UNITED STATES PATENT AND TRADEMARK OFFICE

10/528,860

Office Action Summary	Application No. 10/528,860	Applicant(s) MAIDEN, MILES	
	Examiner Mr. Terry K. Cecil	Art Unit 1797

DETAILED ACTION

FIG. 1A

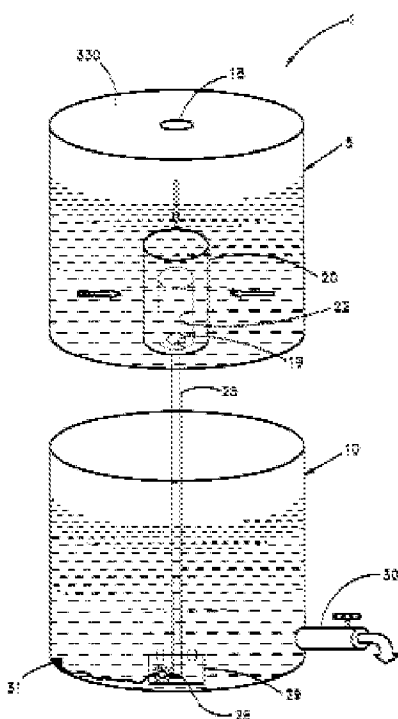
Gadgil teaches many embodiments of a purification module for use with a portable container and teaches all the limitations of the aforementioned claims as follows. The module includes a tubing 25 and a UV lamp [light source] 28 that is a UV LED (col. 5, lines 1-5) and is “most preferably” positioned within the tubing (col. 5, lines 54-56). The UV light source is powered by a [dc] battery source (col. 5, line 9). As evidenced in Gadgil ‘860, a sensing circuit is included for powering the UV light source whenever water is inputted into the inlet and turns off the UV light source when water is stopped being inputted into the inlet (see col. 13, lines 58-62

of Gadgil '860). The means for signaling when hydrating fluid is to flow along the path also includes a user-activated on/off switch 44. The turning on and off of the lamp can also be in automatic response to the opening and closing of a valve by a user (see claims 46 and 47 of the primary Gadgil reference). Also, as disclosed in Gadgil '860, a solenoid valve 29 is configured to stop the flow water if there is a stoppage of power to the UV light source (which would coincide with a loss of sufficient intensity to treat the water). The UV light source doses the water with at least about 40mW-s/cm² (or 40mJ-s/cm²). A ceramic filter 20 is also provided to remove sediments from the water before UV treatment. The filter 20 also slows down the flow past the UV light source such that the water is thoroughly treated. The flow path can also include a widened section for UV treatment (see 29 at figure 1, or figure 2, or figure 10). A pump can also be included for introducing water (col. 3, lines 63-65).
